1. The specifications and drawings for Invitation No. DACW64-02-B-0039, Dredging, Baffin Bay to Port Isabel in Nueces, Kleberg, Kenedy, and Willacy Counties, Texas, advertised 9 August 2002, and for which bids are to be opened on 10 September 2002, are hereby modified as follows:

GULF INTRACOASTAL WATERWAY, TEXAS
DREDGING
BAFFIN BAY TO PORT ISABEL

"THIS DRAWING ACCOMPANIES
AMENDMENT NO. 0001 TO
INVITATION NO. DACW64-02-B-0039".

Sheet 5f 38
File No. IWW 1175-255

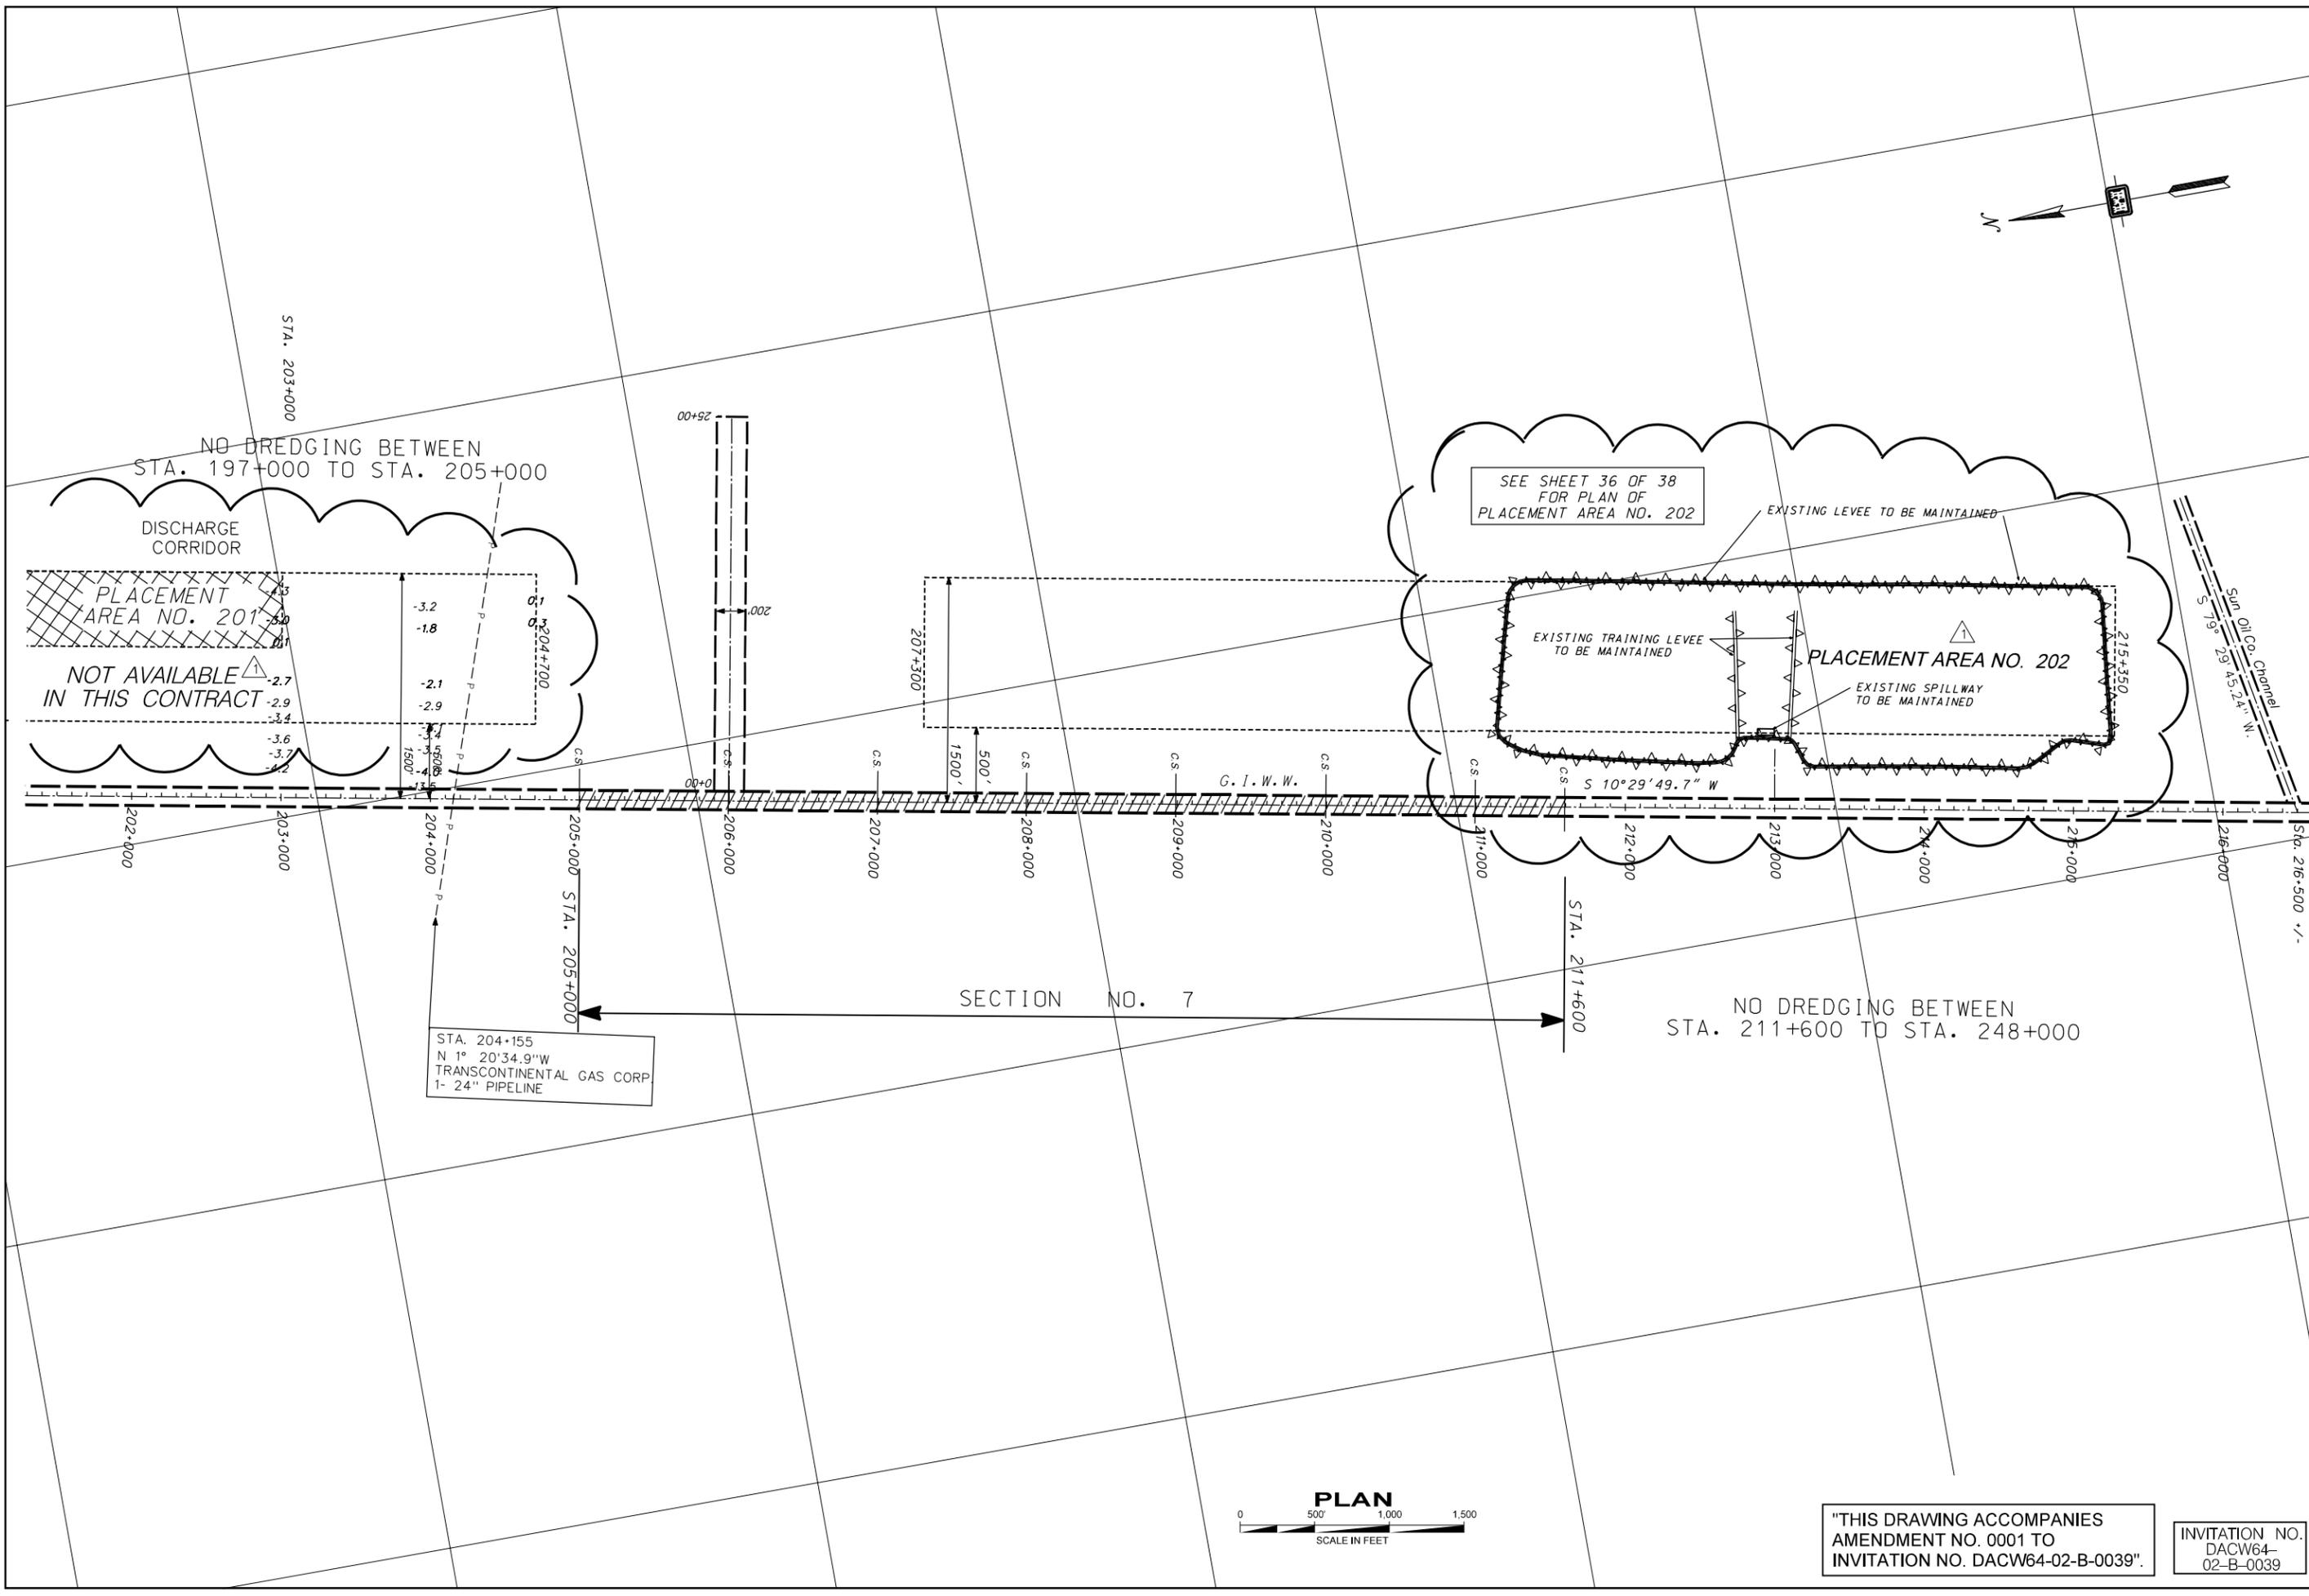
(4) Sheet 5 of 35. - The enclosed Sheet 5 of 38 shall supersede Sheet 5 of 35 issued with this Invitation.

Rev.	Date	Description
1	08/28/02	AM 0001 P.A. 201 IS NOT AVAILABLE & P.A. 202 IS AVAILABLE. THIS CONTRACT IS AVAILABLE.
